Results of Recirculation Ballot on Draft Standard D4.1

Comments (with Dave's comment)

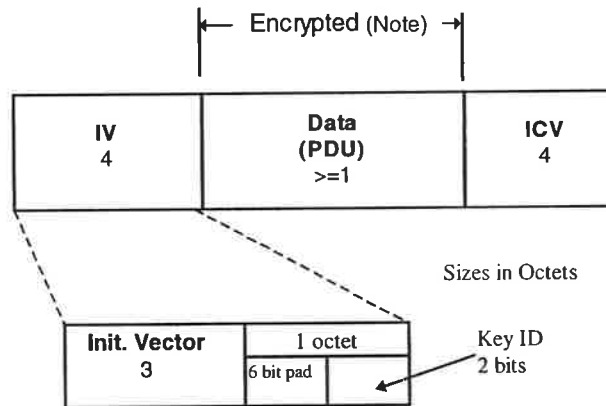
12	8.2.5 (figure 35)	mif	E	(na)	<p>Text was added to the 2nd paragraph of Clause 8.2.5 at the July 1996 meeting to clarify IV field bit ordering by referring explicitly to the ordering conventions in Clause 7.1.1. However, Figure 35 was not updated to show the key ID bits at the left side of their octet, which is needed for consistency with the order stated in the text: "The key ID occupies the two least significant bits of the last octet of the IV field, while the pad occupies the six most significant bits of this octet."</p> <p>(I had to convert the drawing from its original format to "Word 6.0 Picture Object" before Word 6 for the Macintosh would let me edit the drawing. It may be preferable to make equivalent changes in the original drawing rather than inserting the picture object to the right in place of the existing Figure 35.)</p>	<p>Replacement for Figure 35 drawing: Figure is reproduced at the end of this document.</p>

Note: The encipherment process has expanded the original MPDU by 8 Octets, 4 for the Initialization Vector (IV) field and 4 for the Integrity Check Value (ICV). The ICV is calculated on the Data field only.
